Type of Notification: Product Discontinuation

ISSUE DATE	LAST BUY DATE	NOTIFICATION NO.	LAST SHIP DATE
30 June 2009	25 September 2009	PCN-20090630-01	30 December 2009

LQ121S1DG41 LCD Module

LQ121S1LG41 LCD Module

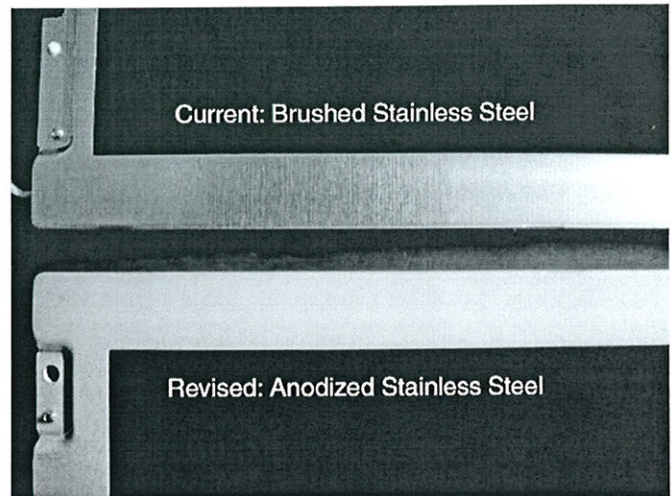
Sharp is discontinuing the LQ121S1DG41 and LQ121S1LG41 LCD Modules to allow for subcomponent standardization. Drop-in replacement parts are available, and are fully form, fit, and functionally compatible.

The replacement for the LQ121S1DG41 module is the LQ121S1DG42; the replacement for the LQ121S1LG41 module is the LQ121S1LG42. These drop-in replacements are fully mechanical and electrically compatible. The Table below gives specific comparisons.

The appearance of the replacement modules differs. The photo to the right details the change.

SPECIFICATION	LQ121S1DG41/LG41 (OBSOLETE)	LQ121S1DG42/LG42 (REPLACEMENT)
Bezel Material	Brushed Stainless Steel	Anodized Stainless Steel
Lamp Vendor	Stanley	Stanley, Hitachi
